GRB/GRRF Joint Informal Working Group on Special Tyre Definitions

Agenda item 4. Further discussion on snow tyre thresholds

Submitted by the experts from Norway

Figure 1. ETRTO results presented on the meeting in August.

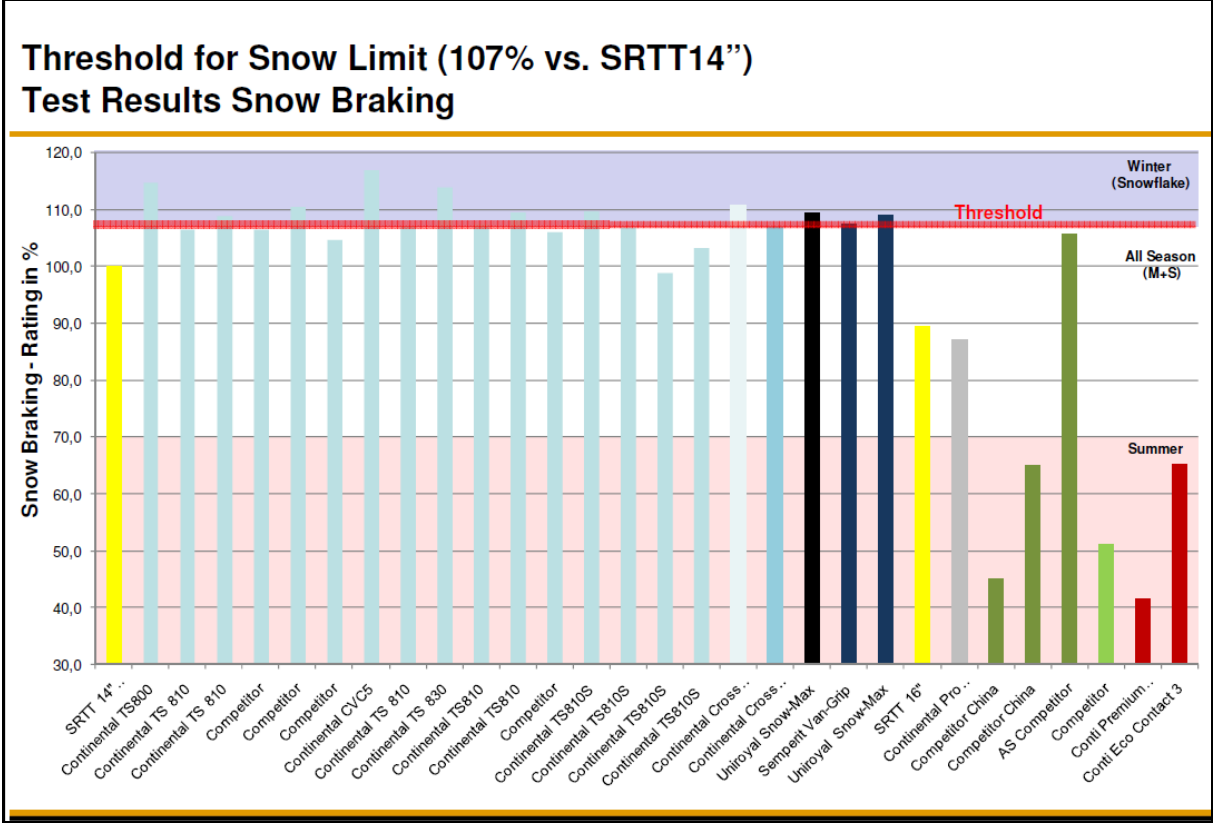
ETRTO presented some results from snow braking tests at the last IG STD meeting. In our view this was too little information to conclude on a definition for snow tyres, and we hereby give documentation available at the moment and propose further work on the issue.

Figure 2. ETRTO data sorted by year of production

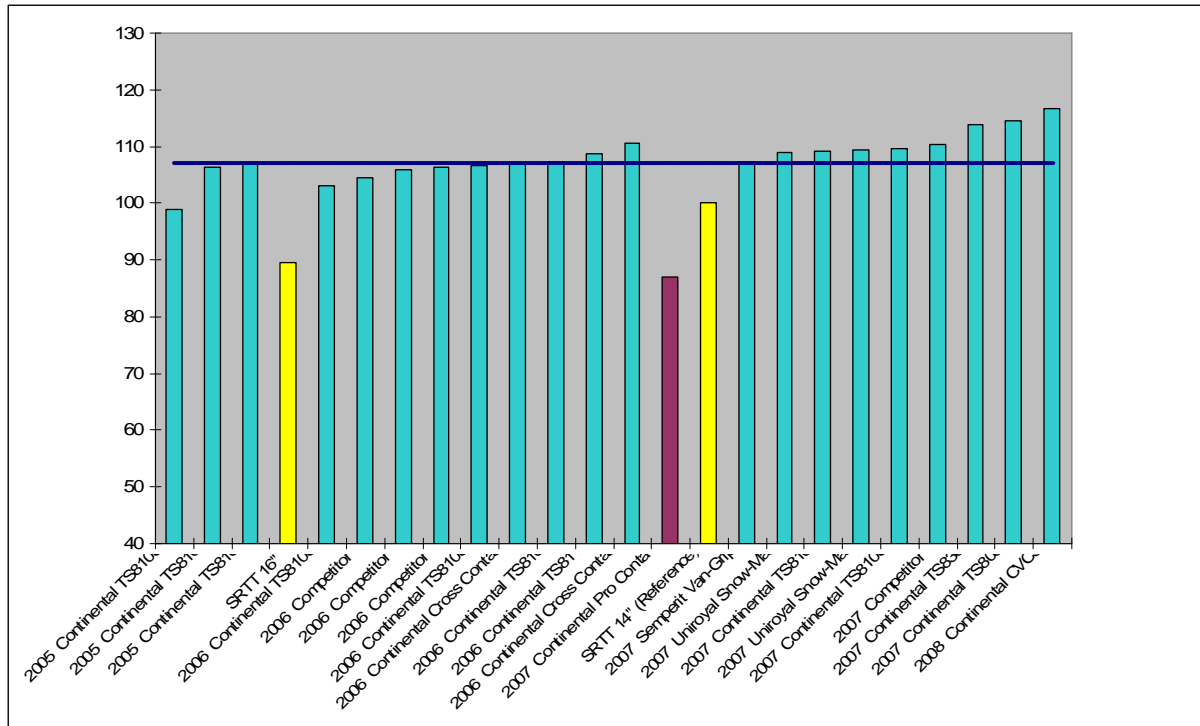
We have put the same data as ETRTO, except for the summer tyres and most of the all season tyres (dark red), into a diagram, and did the sorting after the year of production. As the diagram illustrates, only tyres from 2005 and 2006 fail the 107% threshold, and all the tyres from 2007 and the 2008 (only one!) passes.

Figure 3. Correlation between braking distance on ice surface versus braking distance on snow surface

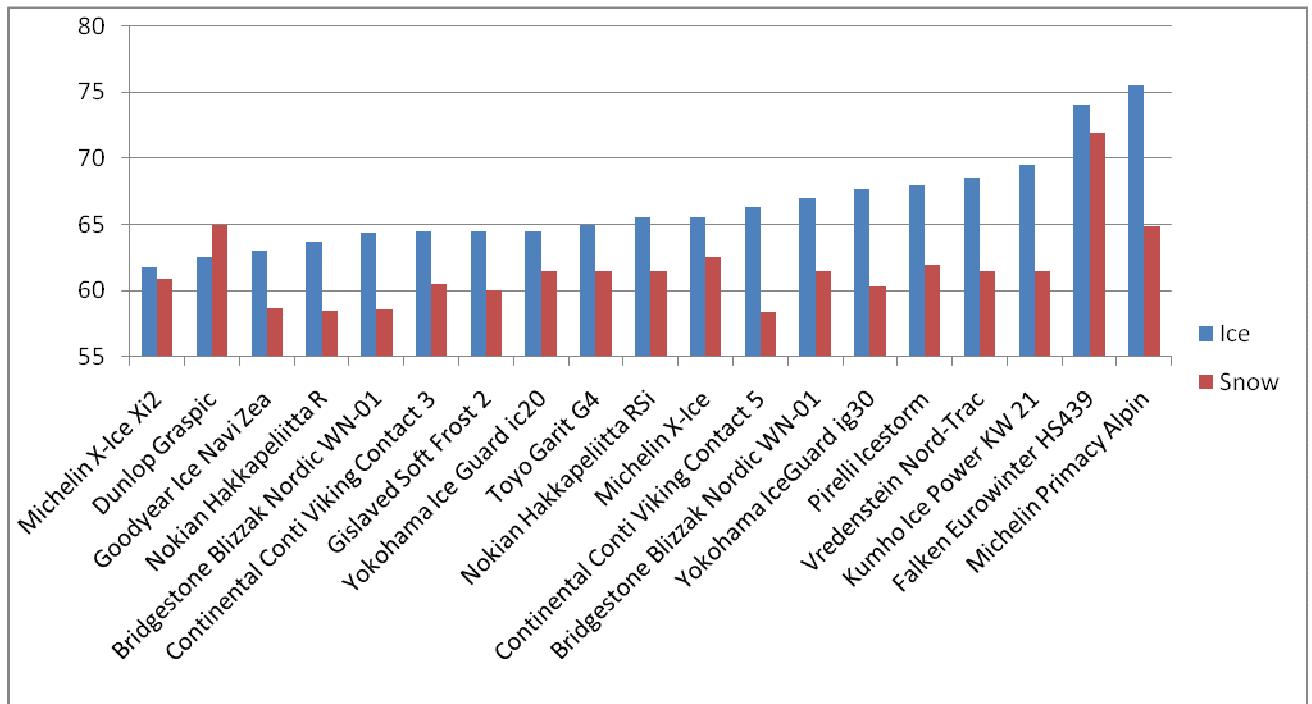
Braking distance on ice surface versus braking distance on snow surface

Correlation: 0,63

A bad braking grip on ice can be crucial. Since there seems to be a poor correlation between braking distance on snow versus braking distance on ice, we think it is necessary to include both as function demands for a snow tyre. Especially since braking on ice is considered a more critical parameter than braking distance on snow for the Nordic consumer (according to the motor magazines).

Figure 4. Correlation between braking distance on ice surface versus braking distance on wet asphalt surface.

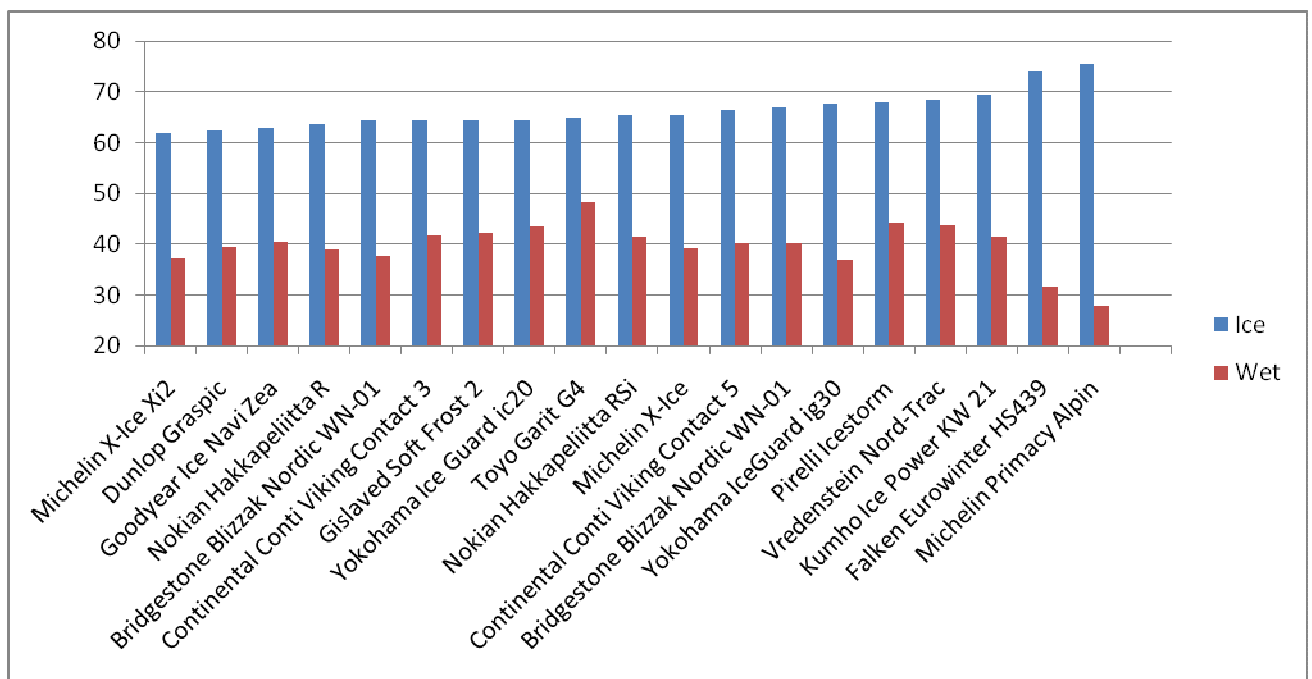
Braking distance on ice surface versus braking distance on wet asphalt surfaces

Correlation: - 0,56

What our sources have told us, and what also seems to be confirmed by figure 3, is that braking distance on ice is negatively correlated with braking distance on wet pavement. The tests are done in relatively cold weather, not as required for a standard wet grip test. Because wet grip also is a very important property for a winter tyre, we think wet grip in cold temperatures (i.e. 1-8°C) also have to be a functional requirement for winter tyres. Our sources have also stressed the fact that if only snow grip and ice grip are included, the focus will be less on the wet grip (since wet grip and ice grip seems to be adversative qualities) and this could affect the traffic safety when driving on wet pavements which also occur in winter time.
